DEVELOPMENT APPLICATION ASSESSMENT REPORT

Application Number:	DA2024/0904
----------------------------	-------------

Responsible Officer:	Thomas Burns
Land to be developed (Address):	Lot 2 SP 51770, 2 / 63 Victor Road DEE WHY NSW 2099
Proposed Development:	Alterations and additions to a dual occupancy
Zoning:	Warringah LEP2011 - Land zoned R2 Low Density Residential
Development Permissible:	Yes, under State Environmental Planning Policy (Housing) 2021
Existing Use Rights:	No
Consent Authority:	Northern Beaches Council
Land and Environment Court Action:	No
Applicant:	Urban Exteriors Patios & Decks

Figure 1: South Elevation

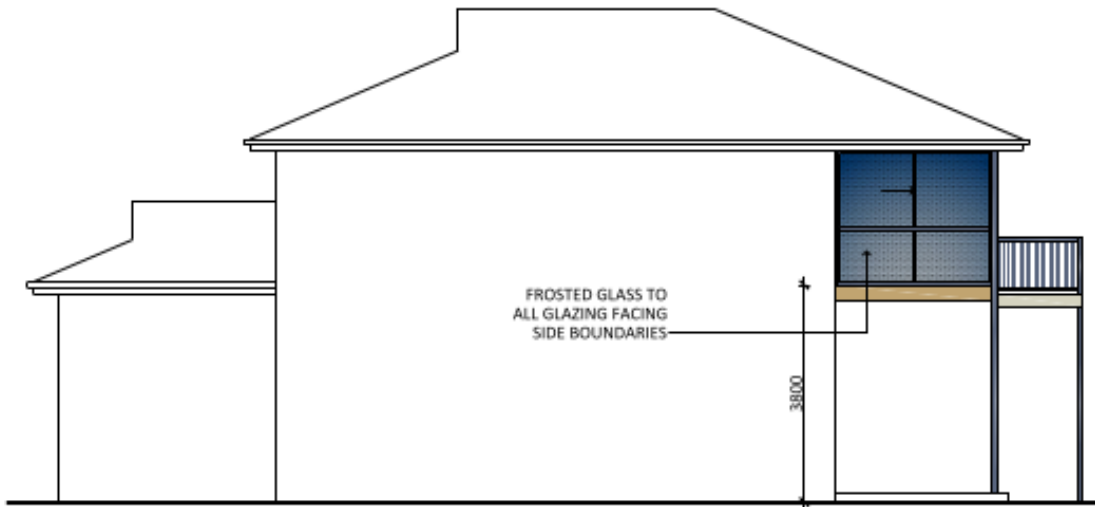
The proposed deck/staircase landing adjacent to the sunroom is elevated approximately 3.6m above ground level and would enable opportunities for overlooking into the southern adjoining property (61 Victor Road). As the area has a width of 1.5m, which is sufficient to accommodate a people to stand or sit on a chair and enjoy the outlook, the privacy impacts that would occur as a result of the overlooking would not be reasonable, given the area is setback 1.44m from the southern boundary.

Accordingly, a condition is recommended to require the southern elevation of the deck/staircase landing to be affixed with a privacy screen. Subject to compliance with this condition, the privacy impacts will be acceptable and in line with the requirements and objectives of section D8 of the WDCP.

A 1.7 metre privacy screen (measured from finished floor level) is to be erected for the entire length of the outermost southern edge of the deck/staircase landing located off the sunroom as shown on the approved plans. The privacy screen shall be of fixed panels or louver style construction (with a maximum spacing of 20mm), in materials that complement the design of the approved development.

Figure 2: Southern Elevation Envelope Breach (shaded in yellow)

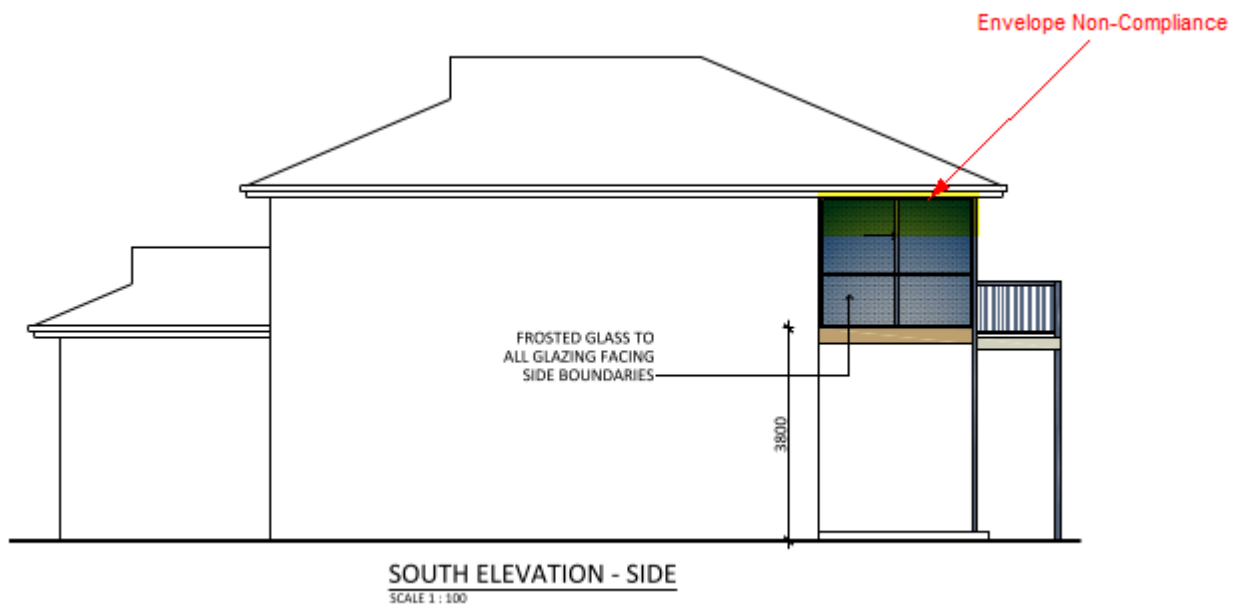
The development includes a 12.82% breach to the side building envelope control on the southern elevation of the sunroom. The extent of the breach is depicted in **Figure 2** below.

The sunroom is located within the footprint of an existing first floor balcony and does not

increase the roof area, building height or footprint of the existing building. The sunroom is also located at the rear of the building and will not be discernible from Victor Road or imposing on adjoining properties, due to the sufficient side setbacks proposed. As such, the development will not become visually dominant by virtue of its height and bulk, notwithstanding the envelope technical non-compliance.

Shadow diagrams have not been submitted with this application; however, Council is satisfied that the development will have negligible impacts on solar access to the southern adjacent property as the development will not increase the overall building height or alter the footprint of the building. Moreover, the side elevations of the sunroom are affixed by floor-to-ceiling height frosted glazing, which will prevent overlooking into adjoining properties to the north and south. In this regard, adequate solar access and privacy will be maintained to adjoining properties, notwithstanding the envelope technical non-compliance.

The development is located within the footprint of an existing balcony and is considered to be an appropriate response to the existing site conditions.

Having regard to the above assessment, it is concluded that the objectives of the control have been achieved. Therefore, flexibility to section B3 of the WDCP has been afforded, consistent with section 4.15(3A)(b) of the EP&A Act.
